# ATTACHMENT 1

## City of Ryde Submission 96 Anzac Avenue West Ryde- SSD-81610714

**Council File reference: COR2025/228**  
**Submission Date: 26 February 2026**

Figure 1: Indicative plan for Sydney Water site in MEEP

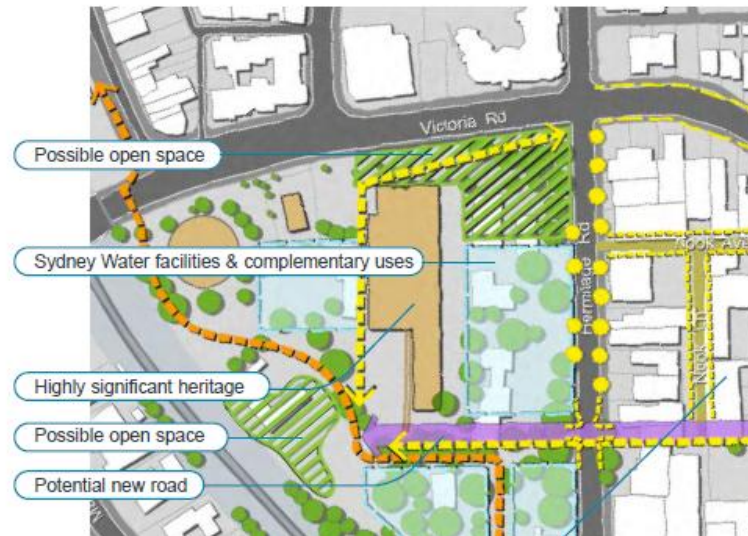
The shadow diagram in Section 8.2.2. in the EIS and Rezoning Report shows that the Ryde Pumping Station and/or its associated site curtilage is shadowed from 9am to 2pm during winter solstice. It is unclear if the overshadowing impact caused by

proposed development will compromise the potential development at the site.

Figure 2: Hydraulic Hazard

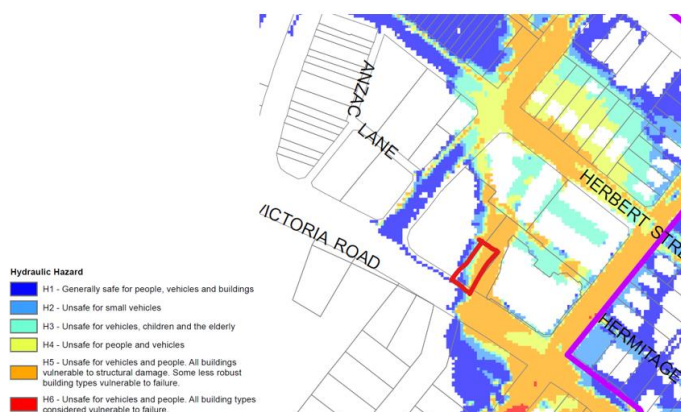
- a. The stormwater management configuration does not address the failure mode of the land (ie in the event of blockage or a storm event exceeding the system, surcharge flows will inundate neighbouring lots). Additionally, the proposal directs runoff to the inground drainage service to the north and this thereby contributes to flooding in Herbert Street. This is contrary to the objective in Council's Stormwater Management DCP which dictates that a drainage system must convey flow with the lay of the land to a valid point of discharge downstream. Noting that there is a public drainage service located in the neighbouring lot to the east, the development may need to formalise an easement through downstream land so as to direct runoff to this point, as per the DCP.

- b. Notwithstanding the above, the design of the OSD system has not considered the potential for a submerged outlet which may occur during extreme storm events. Accordingly, the system is unlikely to operate as designed for large storm events. This may be overcome by relocating the discharge to a point downstream, enabling the storage to be elevated above flood / overland flow and allowing it to freely drain.

## Figure 2: GF and L1 Configuration

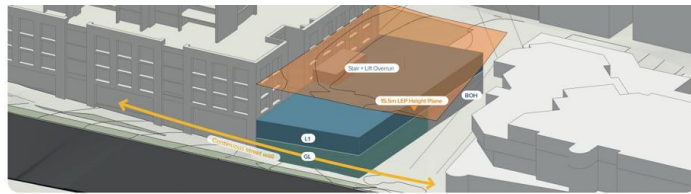
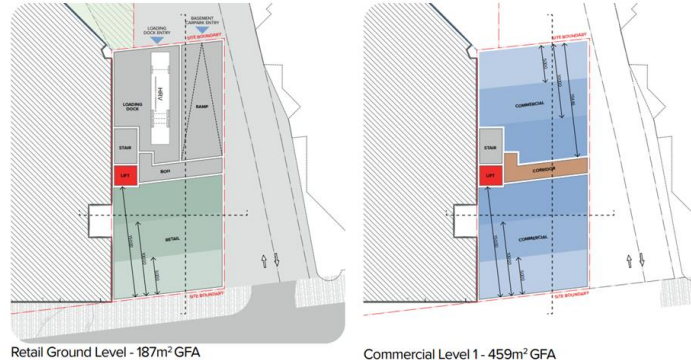
- a. **Overshadowing issues:** Significant additional overshadowing on Sydney Water pumping station façade and possible future open space at the corner of Hermitage Road on Sydney Water land haven't been addressed in the submission package.
- b. **Setback:** The proposal provides a **0-metre setback** to the south-eastern boundary shared with the lot at **935 Victoria Road**. This assumes that the neighbouring site will be redeveloped to create continuous frontage. However, 935 Victoria Road has been identified as **high-risk flooding area**, with significant constraints that limit its potential for future redevelopment.

- iii. Recommend providing a minimum of 3m side setback and separation to 935 Victoria Road.
- iv. Consider amenity impacts on residents from podium carpark and public carriageway. All parking should be located below ground and reduce car parking provision to reflect proximity to the train station and bus services along Victoria Road, while encouraging car-sharing and other sustainable transport solutions to mitigate traffic and movement impacts.

**Figure 5: Substandard deep soil area**

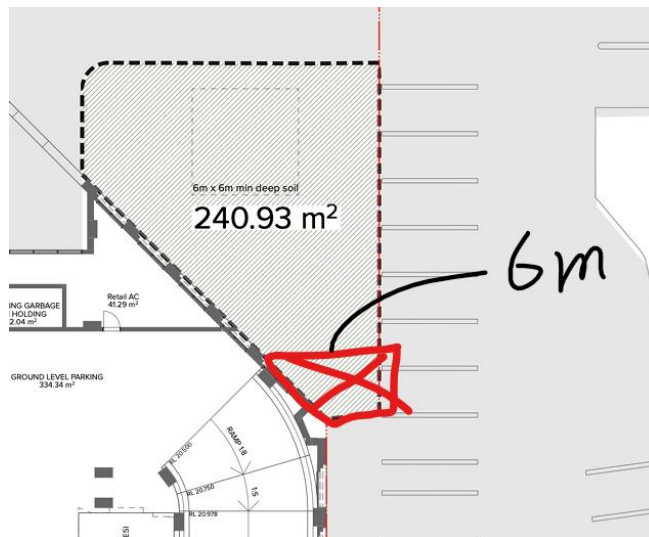
- d. **Deep soil zone:** The deep soil zone must have a minimum dimension of 6m, and therefore the corner area with a width of less than 6m, highlighted in the snip below, should be excluded from the calculation.

- vi. Revisit the deep soil zone calculation to ensure the required 7% of the site area is achieved.

**Figure 6: Town Centre Analysis (EIS)**

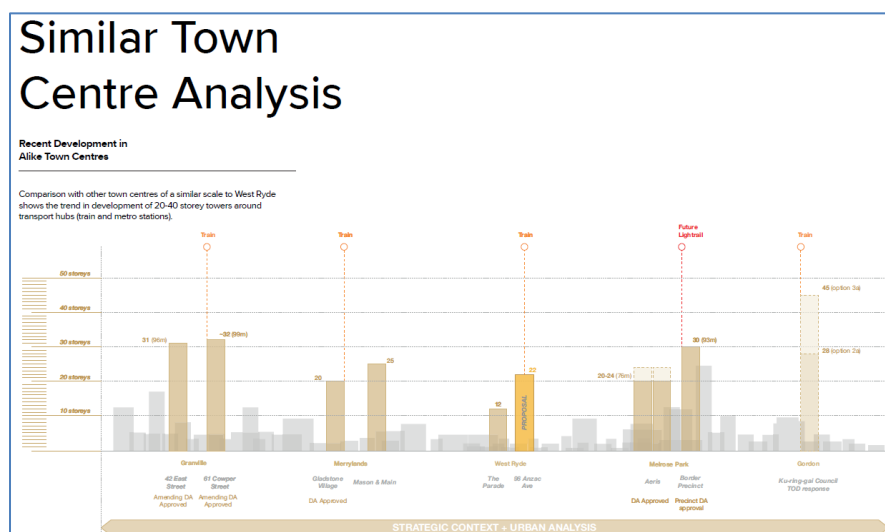
- e. **Building height benchmark:** The benchmarks selected to justify the proposed height (Granville, Melrose Park and Merrylands) are not comparable.

Granville and Merrylands are only one stop from the Parramatta CBD and are both serviced by multiple railway lines. Melrose Park is a large precinct-scale redevelopment transitioning from former industrial lands, with a compact urban form and higher built form across the precinct. Ku-ring-gai Council's alternative Gordon scheme concentrates density and height around the station and manages the transition from the station precinct to the surrounding low-rise residential areas, while excluding the application of LMR policies to lots within the defined TOD boundary. The proposed uplifts are tied to other controls, such as specific affordable housing requirements and non-residential FSR controls.

The defined LMR areas in West Ryde is currently subject to LMR controls. The subject site is adjacent to R2 zones to the north and east with maximum 9.5m building height control.

- i. Consider more comparable height benchmarks for the site contributing to the West Ryde local character and future vision. Require providing sufficient uplift justification.

Figure 8: Existing PMF extent

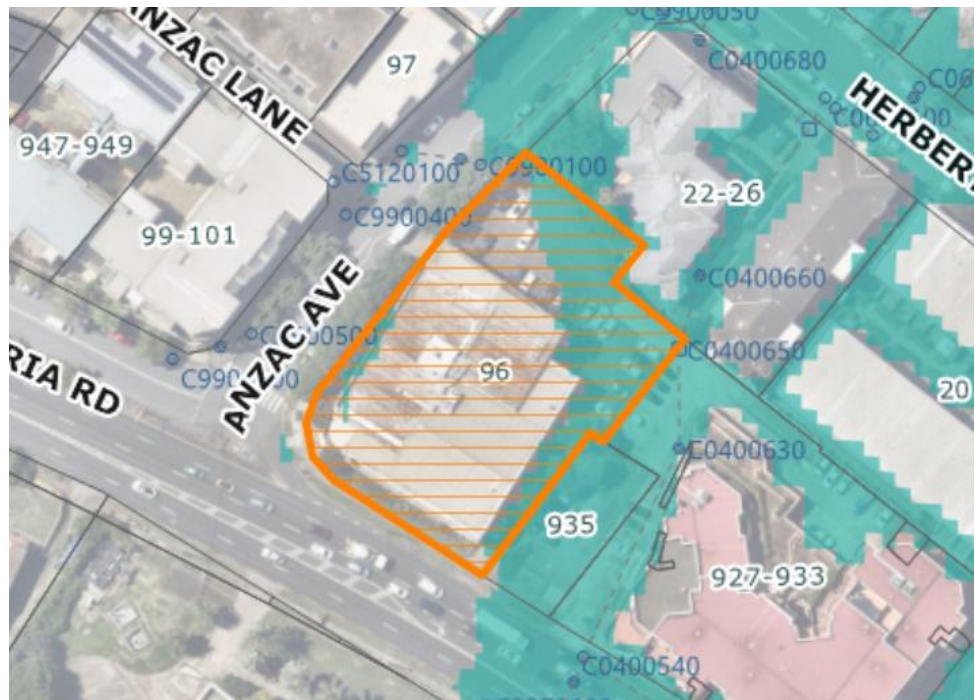
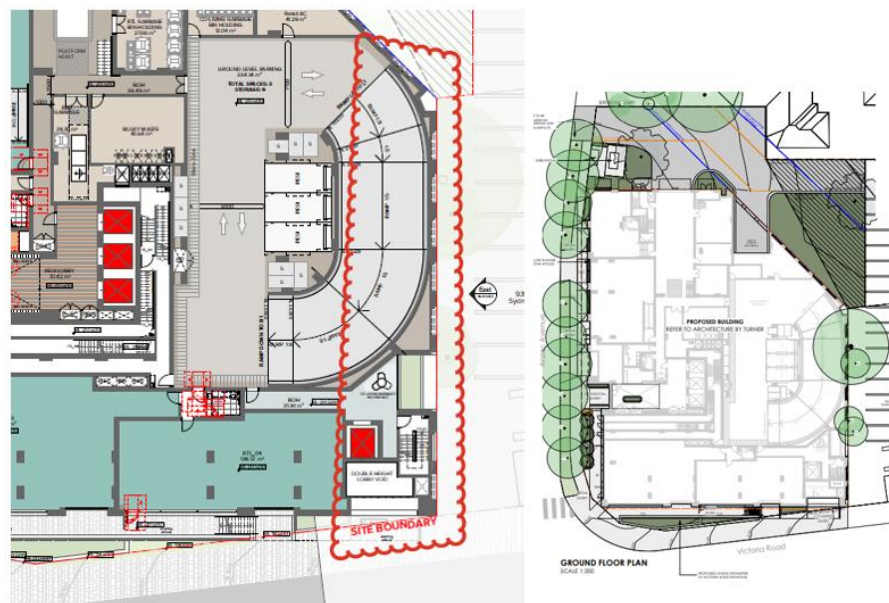
The updated flood impact statement does not clearly demonstrate the 1% AEP and PMF flood extents in relation to the proposed development. This must be clearly shown on plans and appropriately addressed within the flood impact statement to confirm compliance with Council's requirements.

- ii. If the proposed development is of the same footprint, scale and extent as the existing building, this should be clearly stated in the flood study report and demonstrated on the architectural plans for verification.
- iii. Should the flood study report fail to demonstrate compliance with the above requirements, a comprehensive flood study and hydraulic modelling will be required to support the proposal.
- iv. The architectural plans indicate that the proposed development encroaches into a significant portion of the PMF flood extent within the site, as shown in the figure below. Accordingly, the proposal may result in increased off-site flood impacts during the PMF event. Please see Council PMF flood extent map and the architectural maps screen shot below for your reference:

- a. Flood Impact and Risk Assessment (Issue A) prepared by SGC Pty Ltd dated 31 October 2025 to be revised and reflect the below:

- i. Based on Council's previous comments for PRL2025/48, the proposed flood impact statement would only be considered acceptable where there is no encroachment into the PMF or 1% AEP flood extents and no change to existing natural ground levels.

Figure 10: Driveway crest level & flood barrier kerb required

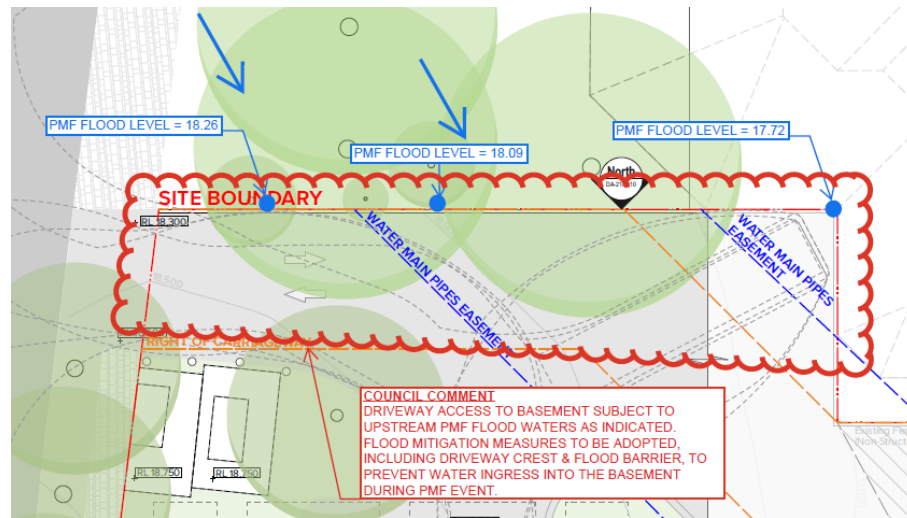
- v. The Flood Impact Assessment recommends a driveway crest level of RL 17.34 m AHD based on the adopted PMF level to assist in preventing floodwater ingress to the basement. However, further review indicates that PMF levels upstream of the site are higher than those nominated in the report.

Additional flood protection measures to be investigated based on the upstream PMF flood conditions at the proposed basement access. These may include revising the driveway crest level and/or incorporating a flood barrier kerb to protect the basement entry, as illustrated in the figure below.

Please note that the provision of flood gates does not replace the requirement to achieve the minimum habitable and non-habitable floor level freeboard requirements.
